## Proposal for amendment to Regulation No. 44

### I. Proposal for a new series of amendment to Regulation No. 44 (Uniform provisions concerning the approval of restraining devices for child occupants of power-driven vehicles ("Child Restraint Systems"))

Figure 0 (a)

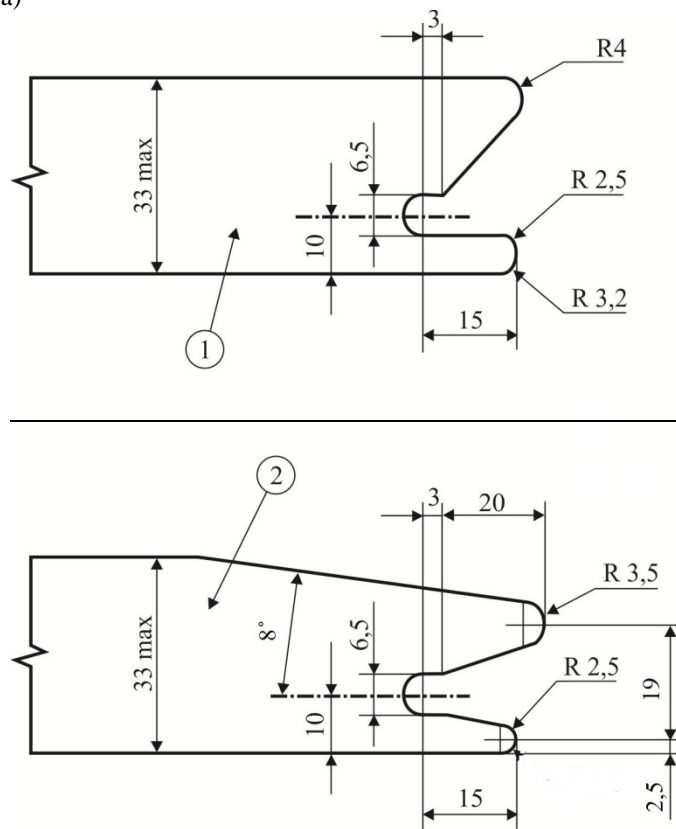
Delete paragraph 6.3.:

————— ISOFIX attachments may be according to examples shown in Figure 0 (a) below, or other appropriate designs that are part of a rigid mechanism having provision for adjustment, the nature of which is determined by the ISOFIX child restraint system manufacturer.

Figure 0 (b)

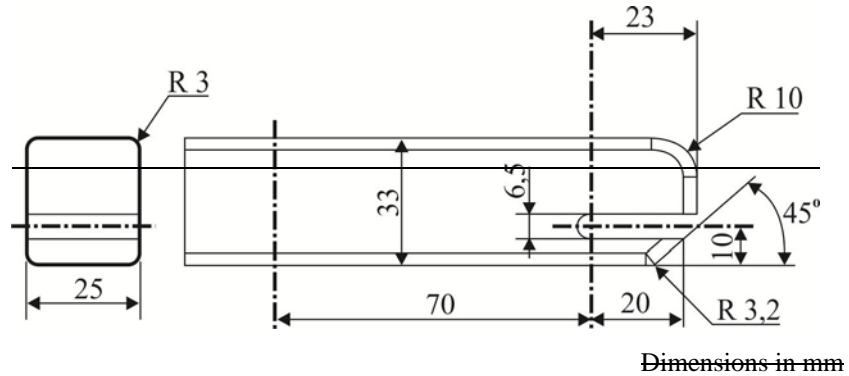
Dimensions for the portion of the ISOFIX child restraint system attachment that engages the ISOFIX anchorage system shall not exceed the maximum dimensions given by the envelope in Figure 0 (b)

Figure 0 (c)  
~~ISOFIX top tether connector (hook type) dimensions~~

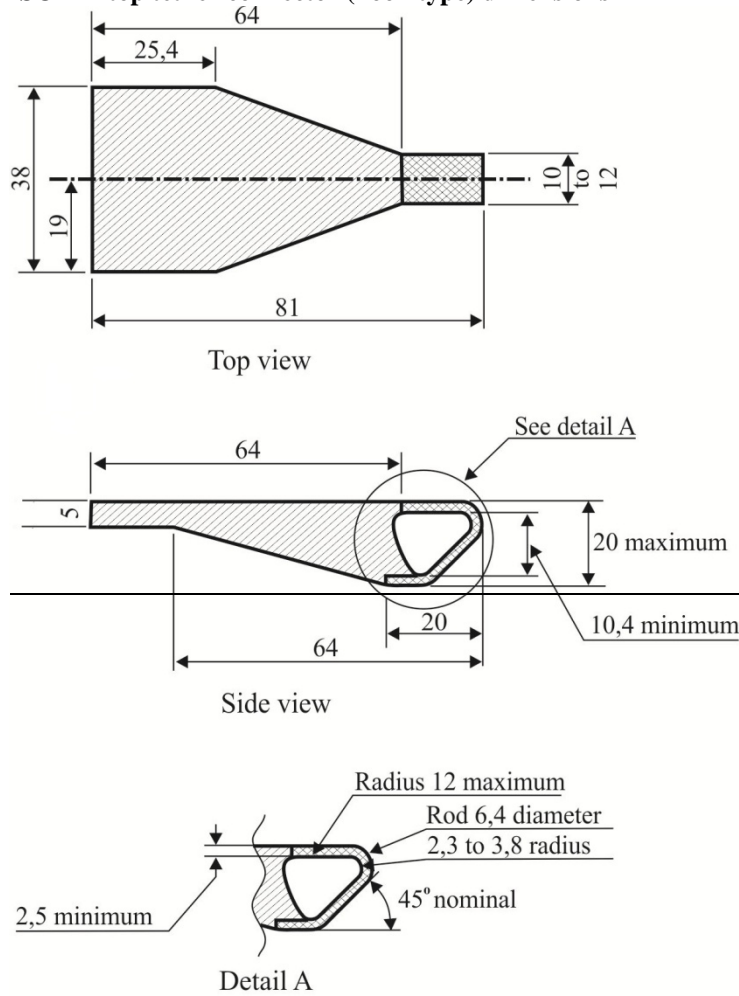
Engagement dimensions for ISOFIX top tether hooks are shown in Figure 0 (c).

Figure 7

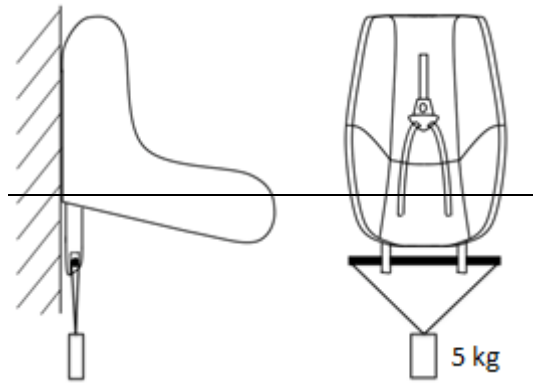
*Delete paragraph 8.2.9.:*

~~8.2.9.~~ The complete seat, or the component fitted with ISOFIX attachments (e.g. ISOFIX base) if it has a release button, is attached rigidly to a test rig in such a way that ISOFIX connectors are vertically aligned as shown in Figure 7. A 6 mm diameter bar, 350 mm long, shall be attached to the ISOFIX connectors. A mass of 5 kg shall be attached to the extremities of the bar.
